GENERAL NOTES

SUM-77 / 277 / 224
VARIOUS

REVISIONS		
NO.	DATE	DESCRIPTION
△	04/28/21	FAA COORDINATION NOTE ADDED & AIRWAY CLEARANCE NOTE REVISED

LIGHT TOWER SCHEDULE

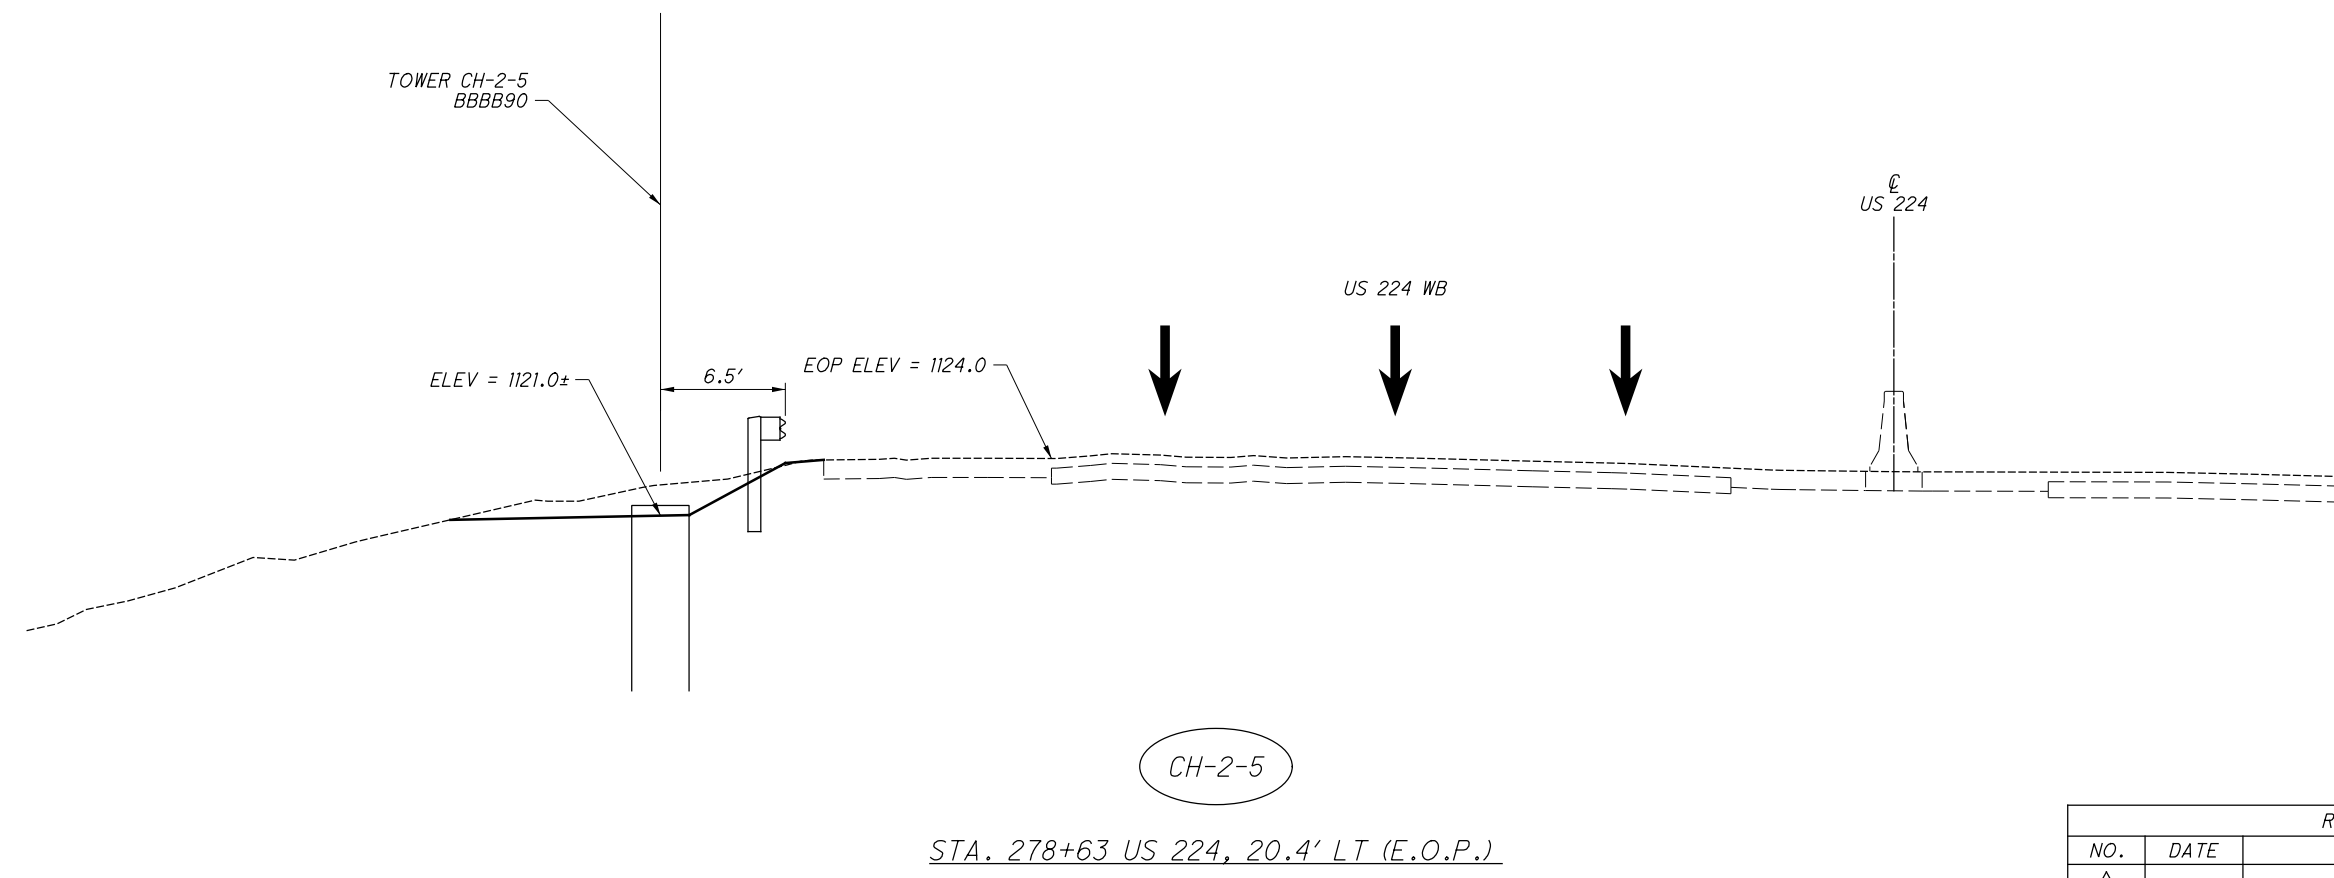
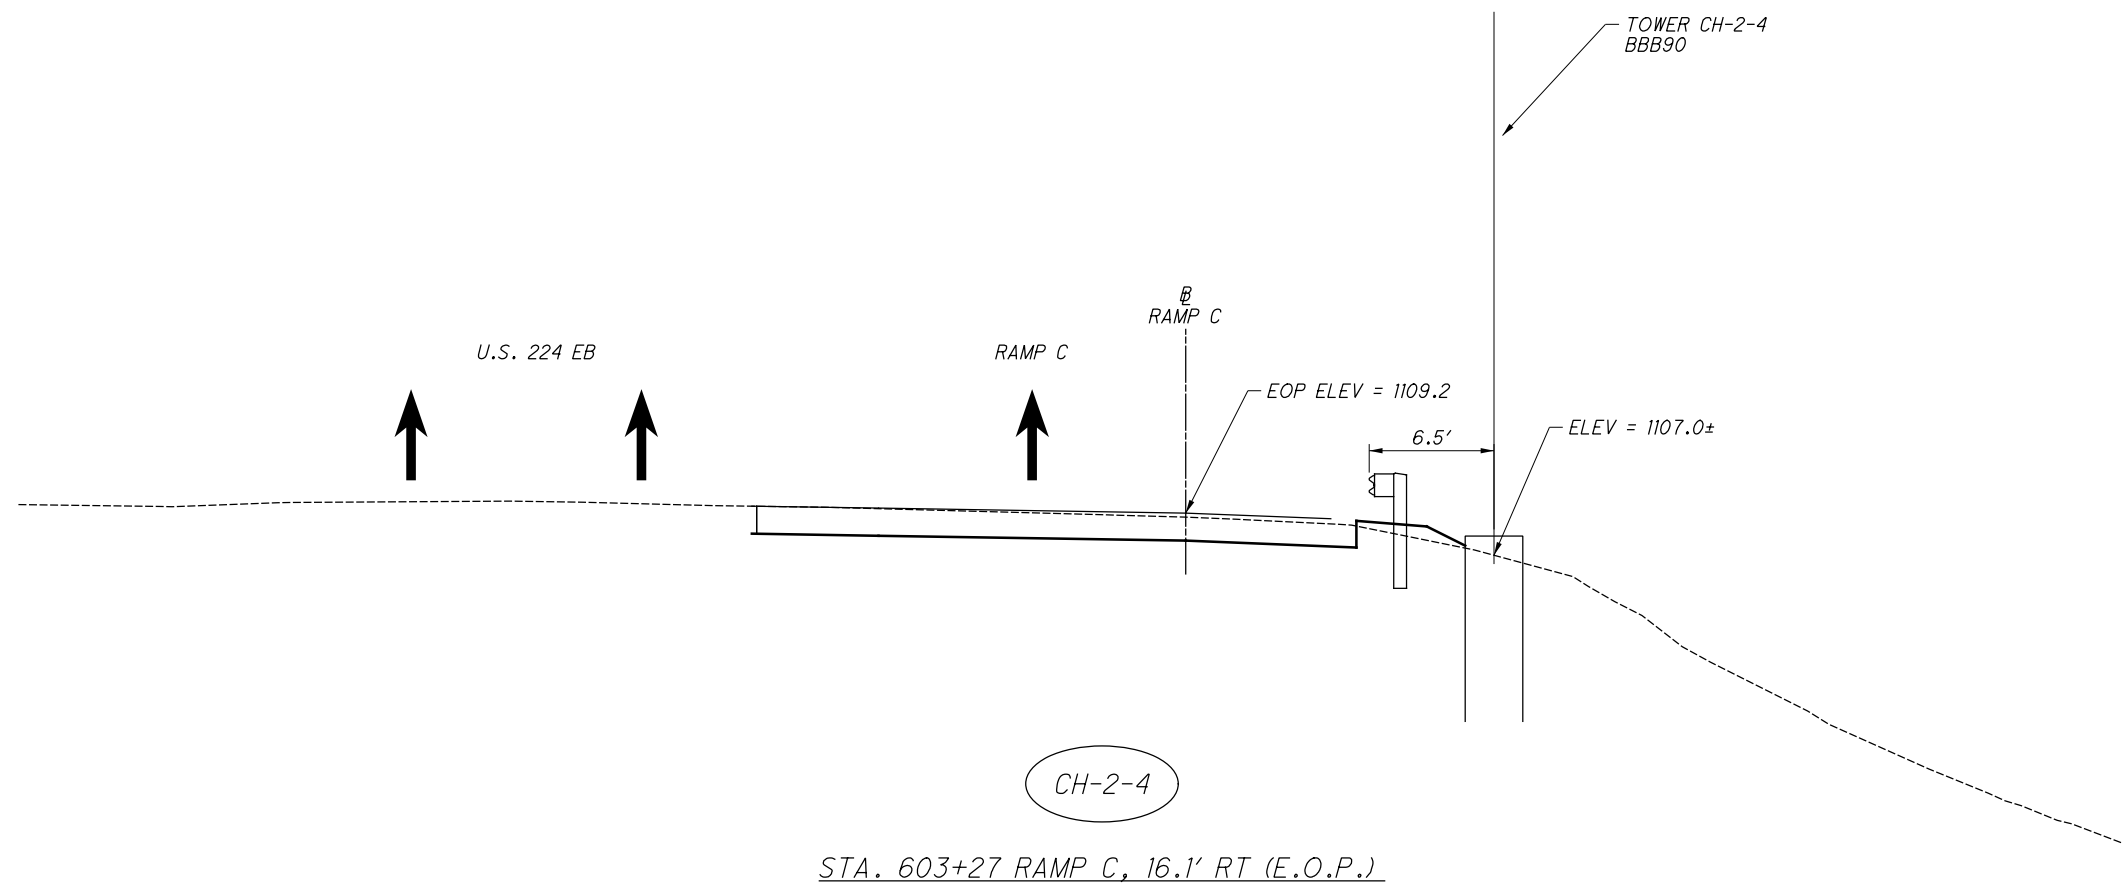
REVISIONS		
NO.	DATE	DESCRIPTION
1055	04/28/21	ADDED FAA FLASHING BEACON
